**TOWN OF SULLIVAN'S ISLAND
DESIGN REVIEW BOARD**

**REGULAR MEETING MINUTES
Wednesday, April 19, 2023**

Re: 2415 Middle St Plans

Please consider the following when ruling on the progression of the home located at 2415 Middle Street.

EXHIBIT 0.0

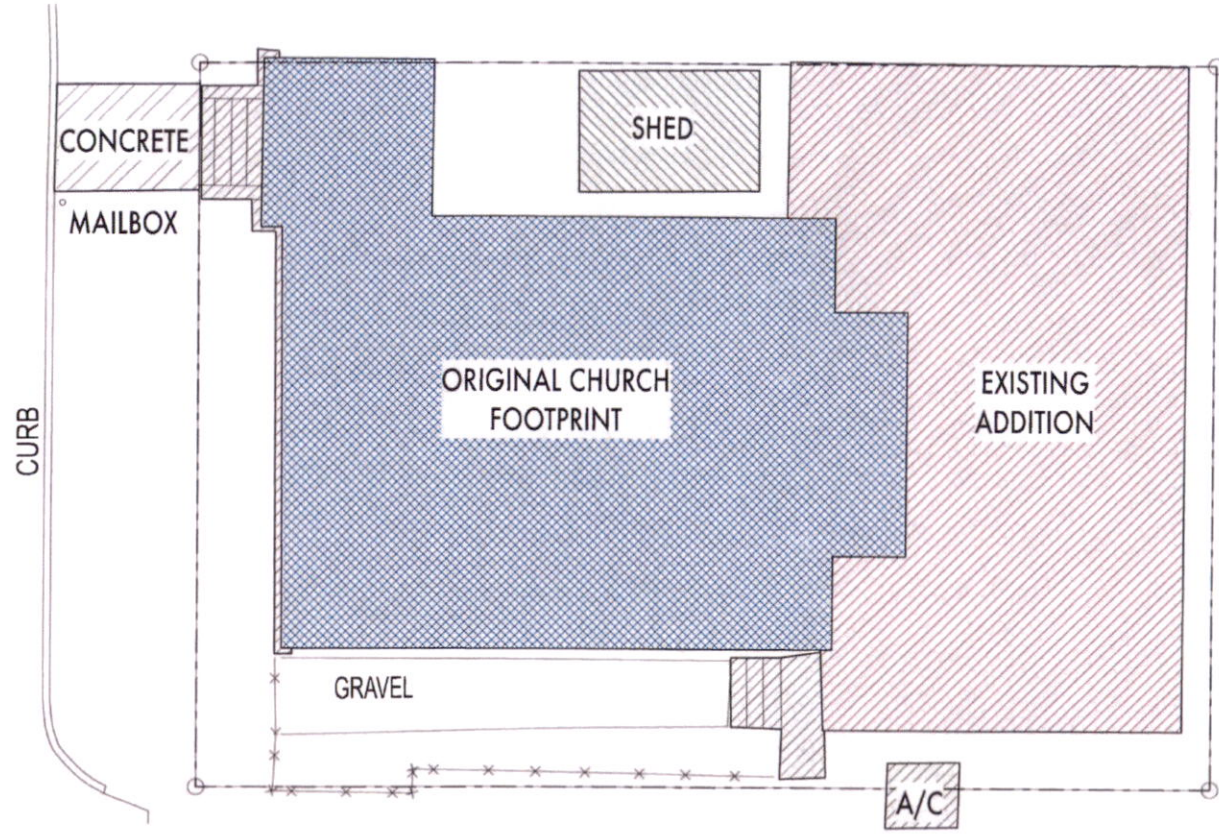
If both the **Exhibit 0.0** "Original Church Footprint" and the "Existing Addition" (as shown on the attached applicant supplied plans) is given historic designation for this plan approval, then how can the back 35%+/- of the house be knocked down and rebuilt with a 100% new 2 story addition **Exhibit 0.1**? You cannot just tear down an historic structure, correct? This would also not qualify as a remodel or change of less than 50% per FEMA guideline would have brought up to current building and zoning regulations.

If the only the "Original Church Footprint" is approved as the historic part, then the existing addition is not historic and if it is altered in a material way it loses it non conformity and would have to be built to current code and zoning regulation or get a variance from the BZA.

The applicant has demonstrated with all submittals and meeting questioning that the "existing addition" is not historic and therefore should not be treated as such. Then any material adjustments to the "existing structure" should be treated separately from the "Original Church Footprint" and should have to go through any BZA for all variances.
